Spray Heat Transfer Coefficients for Jet Pump BWR Fuel Assemblies with Water Rods

ANF-929(NP)(A)
SUPPLEMENT 1 ANSWERS TO QUESTIONS POSED BY THE NUCLEAR
REGULATORY COMMISSION STAFF AND CONSULTANTS ON THE
ADVANCED NUCLEAR FUELS BWR 9X9 SPRAY COOLING PERIOD HEAT
TRANSFER COEFFICIENTS

ANF-929(NP)(A)
SUPPLEMENT 4 ANSWERS TO FURTHER QUESTIONS POSED BY THE NUCLEAR
REGULATORY COMMISSION STAFF AND CONSULTANTS (NOVEMBER
1989) ON THE ADVANCED NUCLEAR FUELS CORPORATION BWR 9X9
SPRAY COOLING PERIOD HEAT TRANSFER COEFFICIENTS: EVALUATE
THE EFFECT OF CHANGED AXIAL POWER DISTRIBUTION

TECHNICAL EVALUATION REPORT

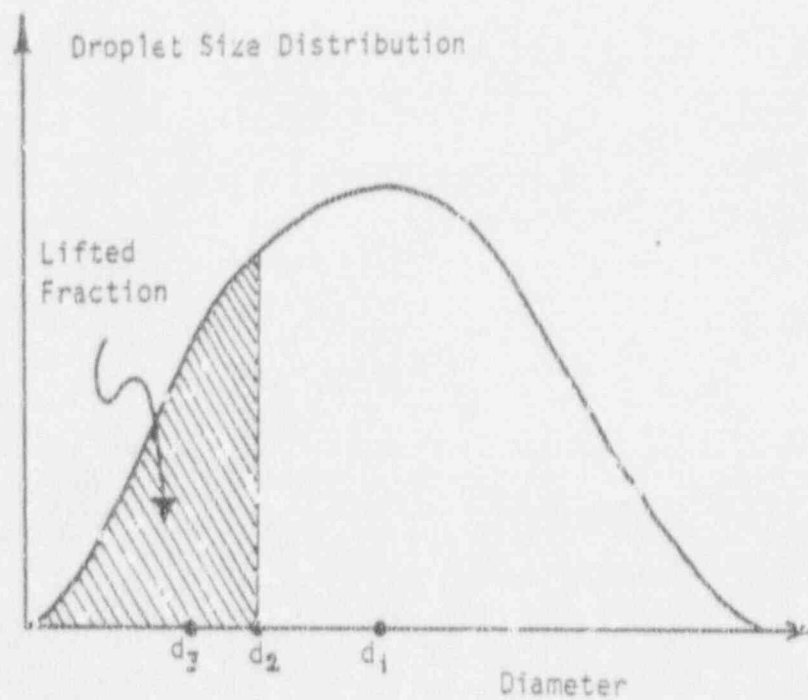
Item 3: The magnitude of the convective heat transfer coefficient is very sensitive to the entrainment fraction and drop sizes entering at the bottom of the bundle. Please explain the method for calculating drop size and also provide justification for the entrainment fraction and drop sizes input to the code. Please provide the comparisons with experimental data under the same hydraulic conditions as those used in ANF-929(P), Supplement 4. The comparisons of the code predictions with experiment should include the parameters, with appropriate code output, similar to that requested in Item 1.0 above.

Response:

Drop Size: An average diameter was estimated for the drops forming in the side inlet orifice using Tatterson-Haaratty correlation. The maximum diameter of drops that can be lifted by the steam flow in the bottom of the bundle was used as a cut-off for calculating the average entrained drop diameter assuming Nukiyama-Tanasawa droplet size distribution. The method is illustrated in the sketch of Fig. 3.1. A fixed value of the average drop diameter was used for all three power shapes. The uncertainties associated with the choice of the drop size are compensated for by the proper choice of drop mass flow rate.

Entrainment Fraction: The entrained droplet mass flow rate was not measured in the experiment. This boundary condition was determined semi-empirically.

This droplet mass flow rate was used for all the three power shapes.
